**STATE OF TENNESSEE
DEPARTMENT OF TRANSPORTATION**

INSTRUCTIONAL BULLETIN NO. 17-09

Regarding Revised Standard Drawings

Effective February 9th, 2018 letting (November 29th, 2017 Turn-in), the following Standard Drawings have been revised. Also, Section 5, Index of Standard Drawings, of the Roadway Design Guidelines has been revised to incorporate these changes.

EC-STR-3B

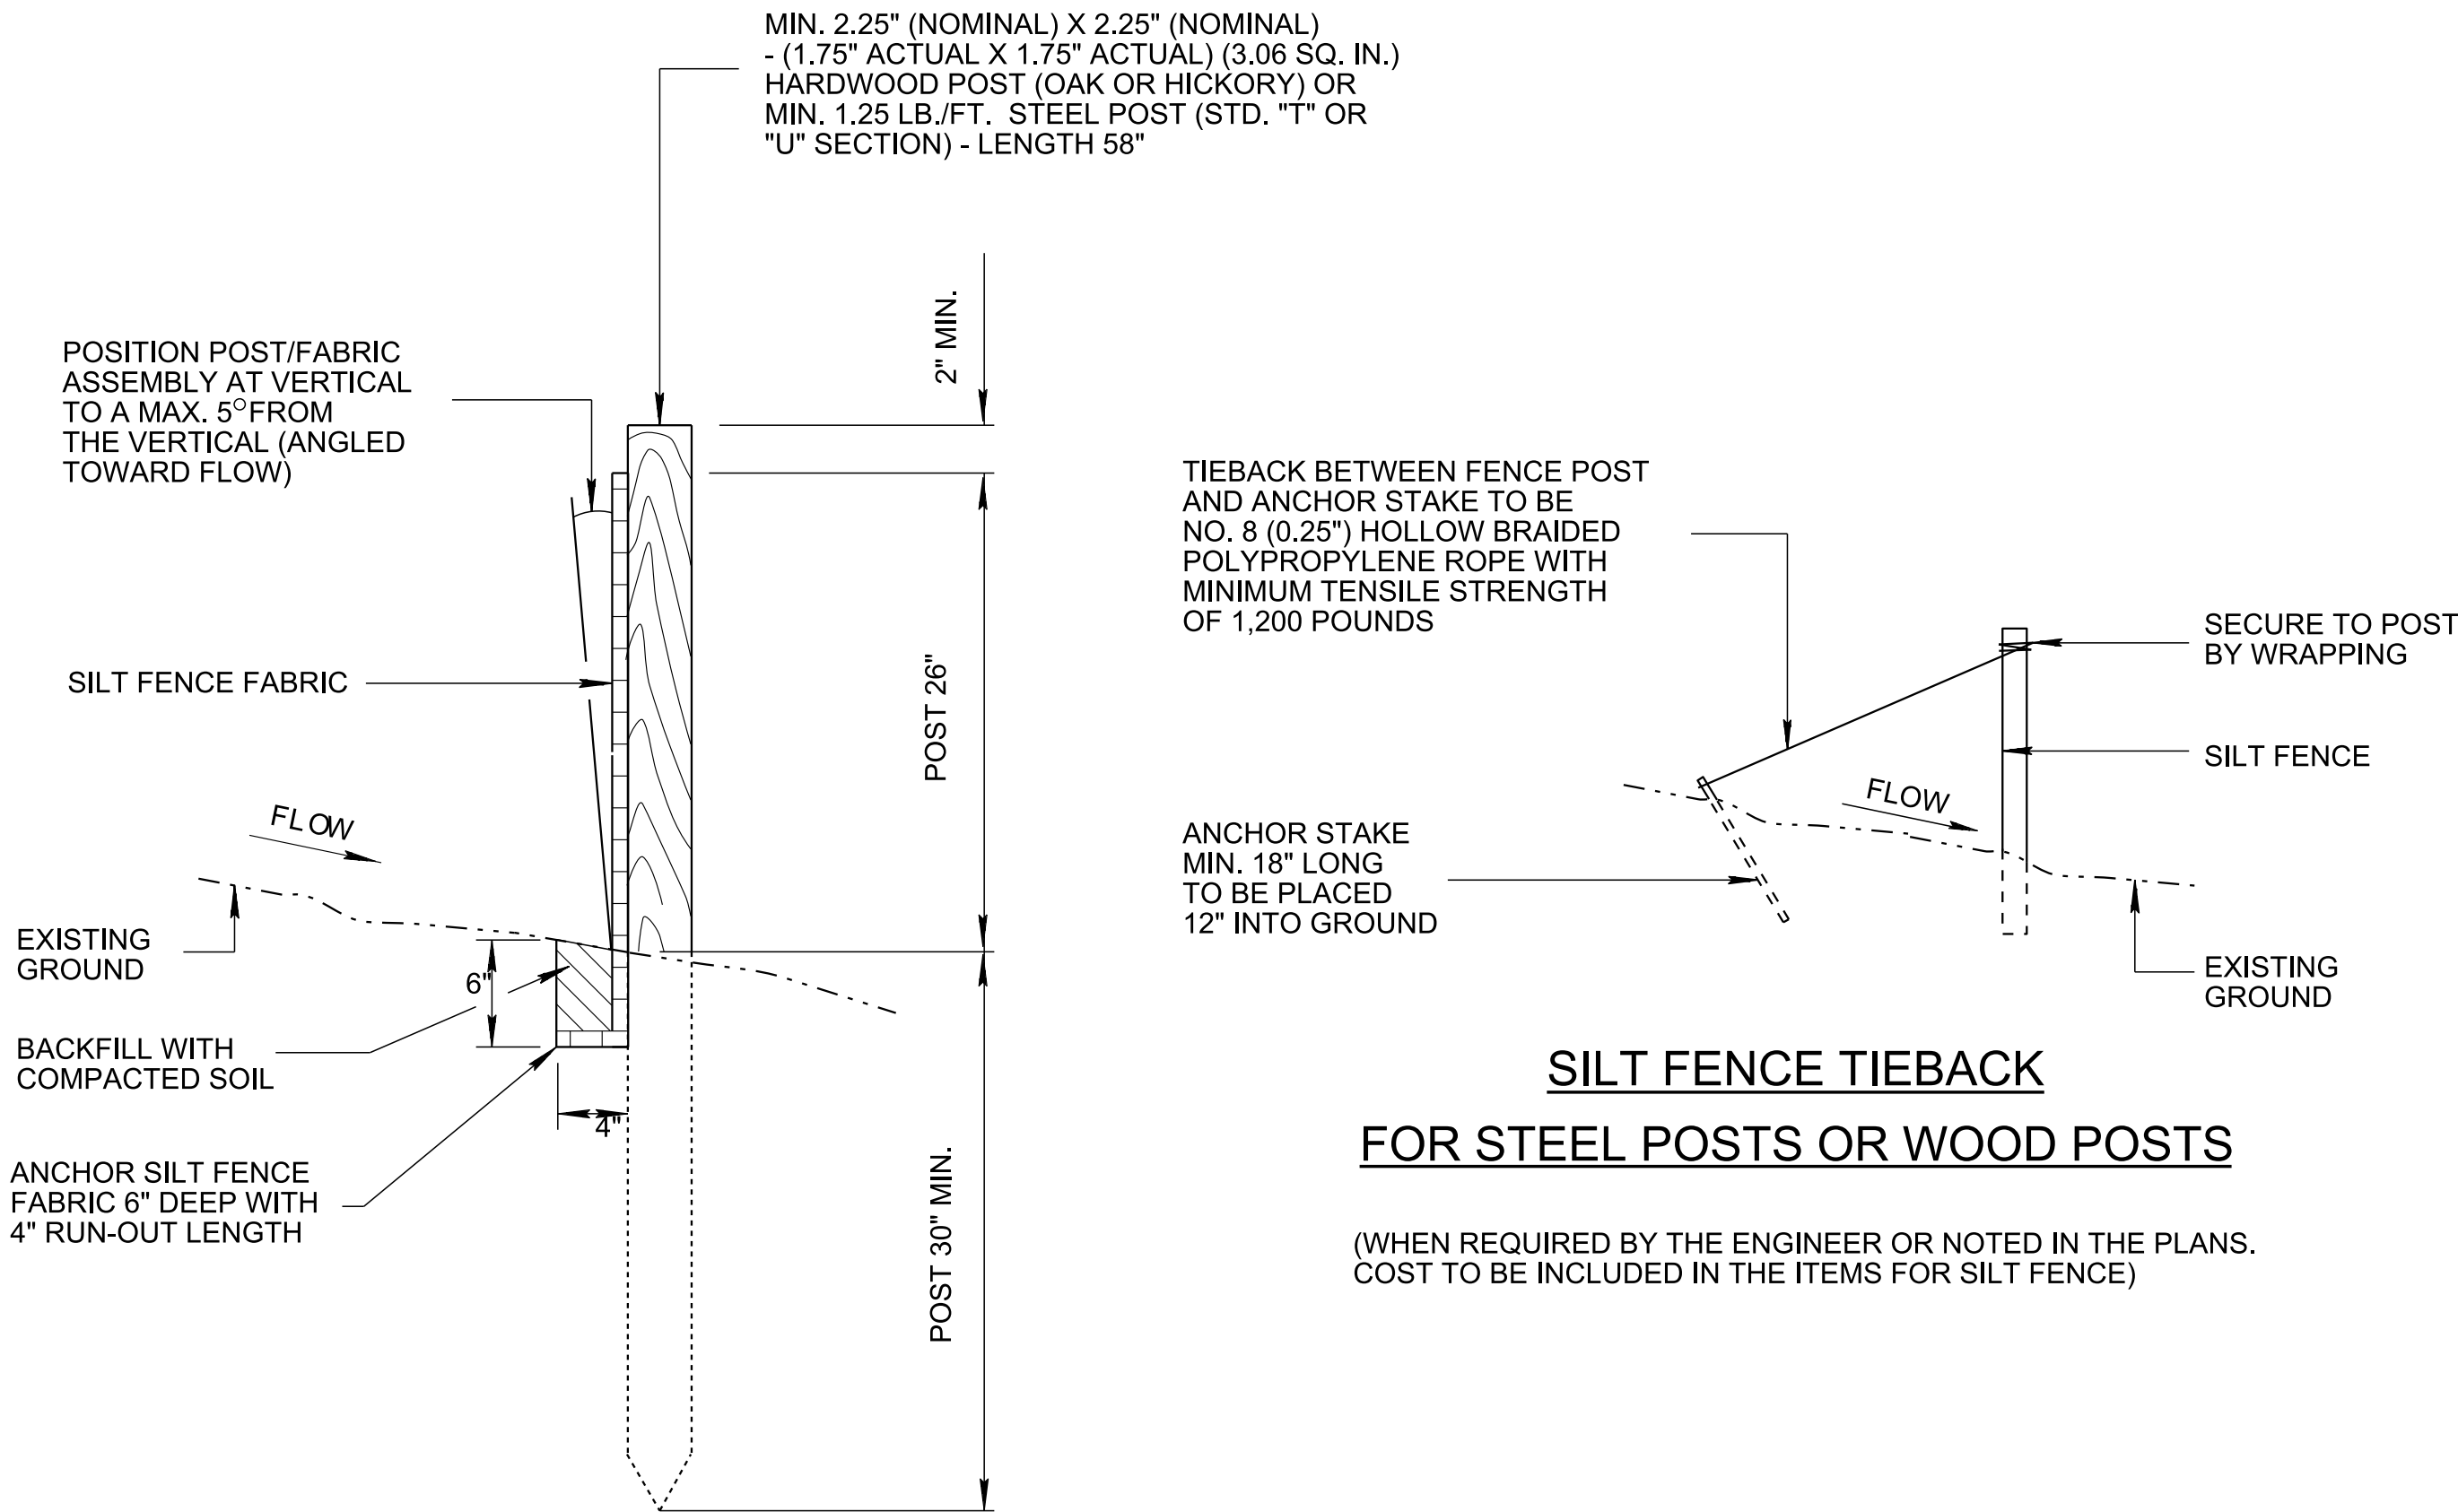
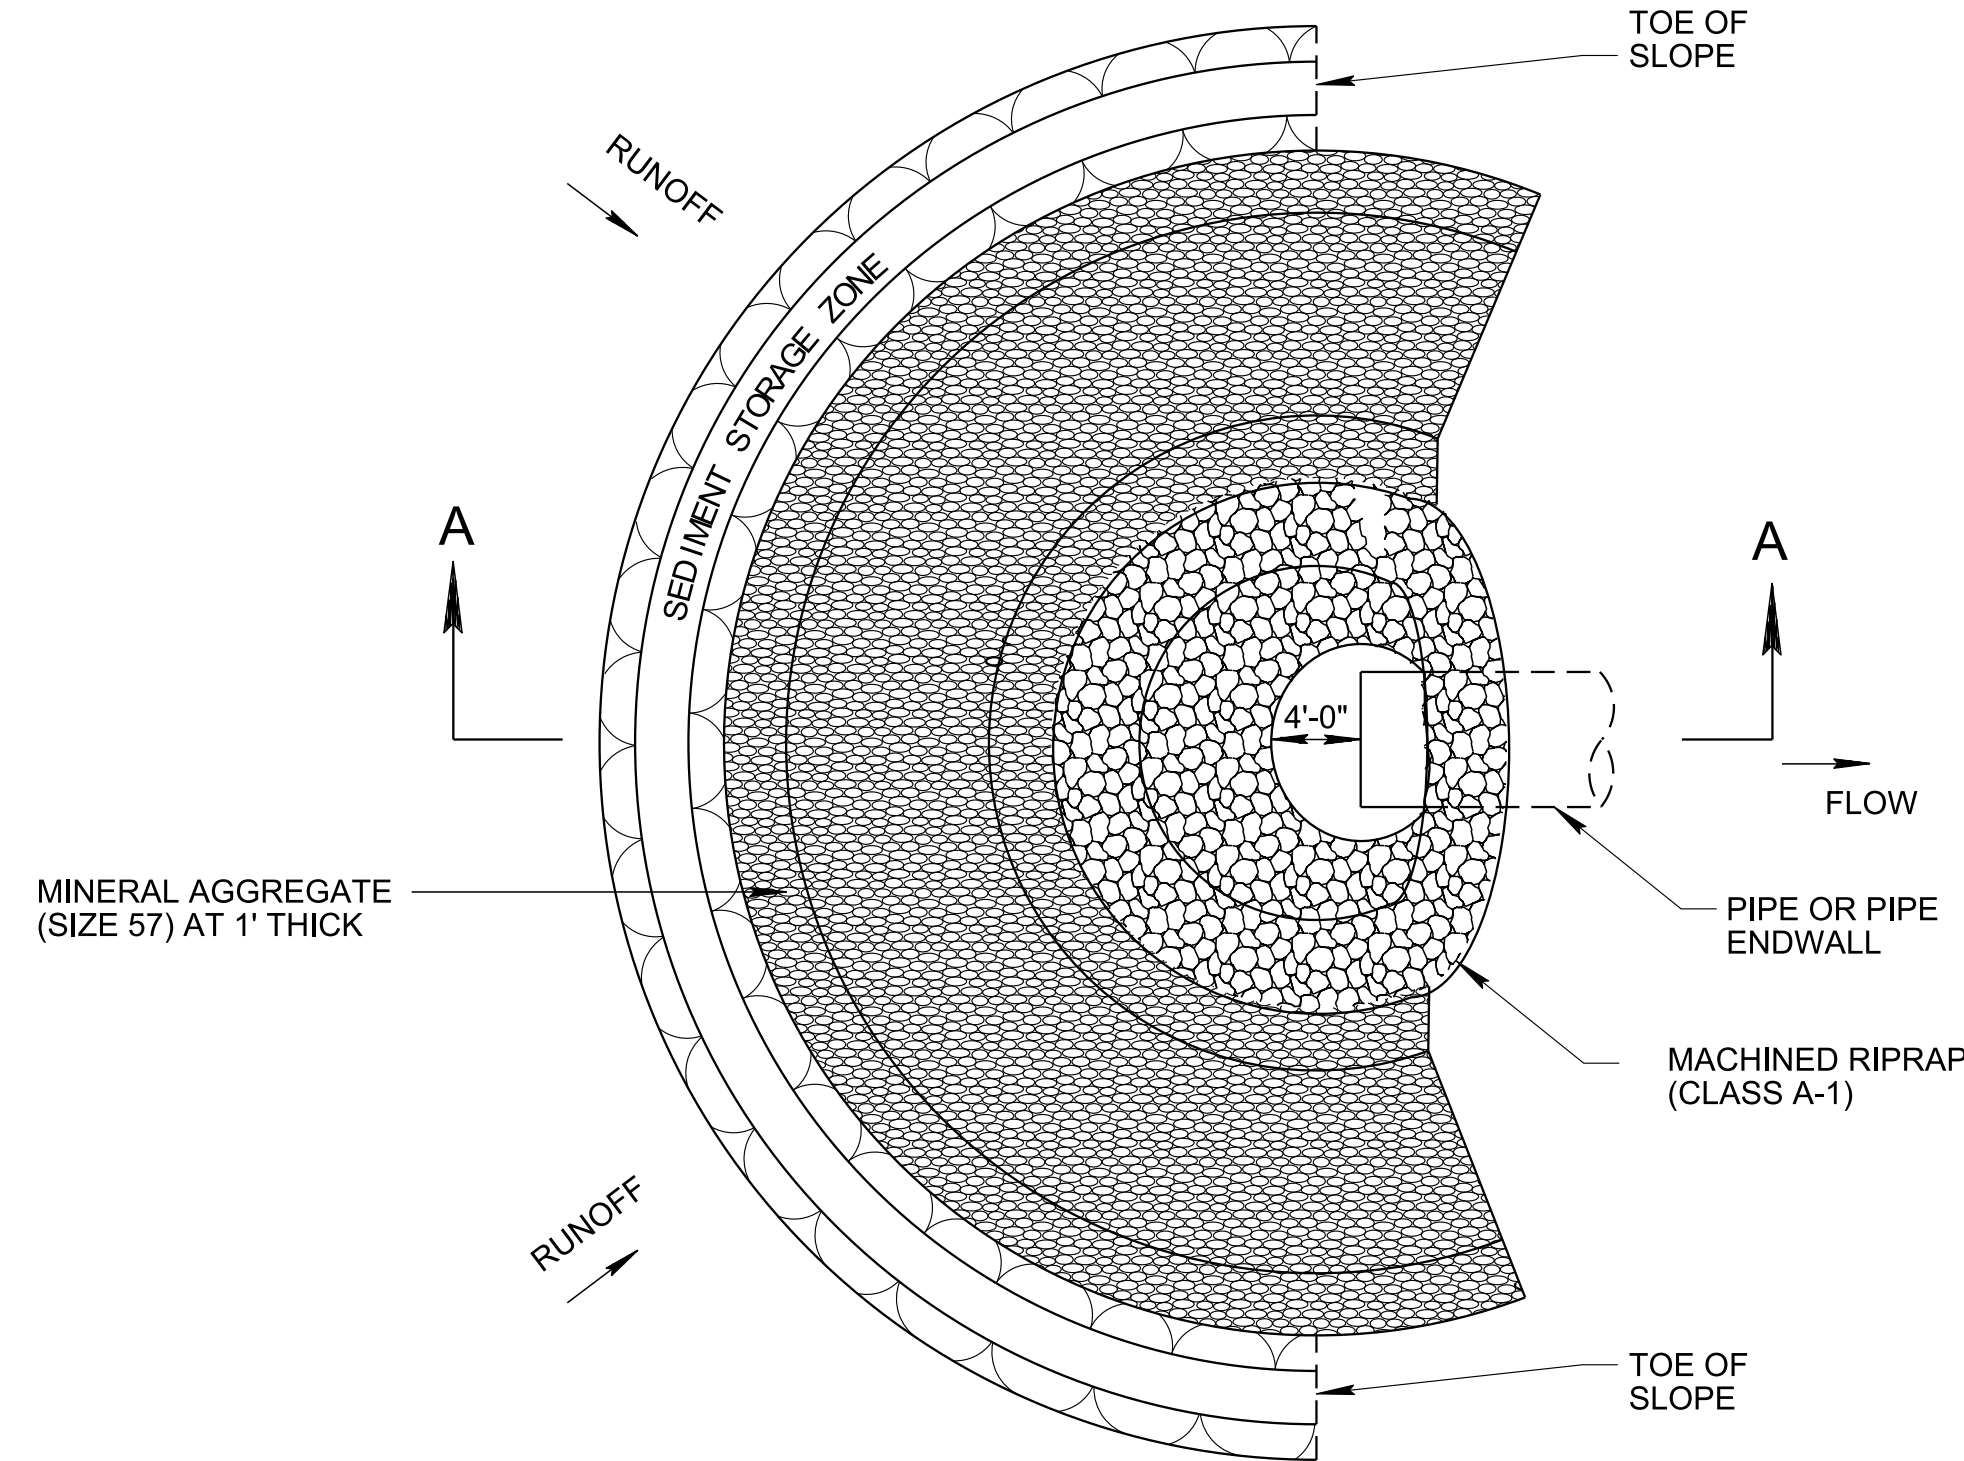
- REV. 12-18-03: MODIFIED TABLE ① AND GENERAL NOTE ⑥
- REV. 7-29-04: CHANGED VALUES IN TABLE ① FROM MEAN TO MARV VALUES.
- REV. 4-15-06: REMOVED POA SPECS. FROM TABLE 1. ADDED NOTE ①. REVISED TABLE TITLE, REORDERED GENERAL NOTES, REFORMATTED SHEET, REVISED NOTES, MISC. EDITS TO DRAWING.
- REV. 4-1-08: REMOVED TEMPORARY REFERENCE, REVISED NOTES, AND MISC. EDITS TO DRAWING.
- REV. 8-1-12: MINOR EDITS TO GENERAL NOTES.
- REV. 3-16-17: CHANGED SECOND NOTE ⑥ TO NOTE ①.
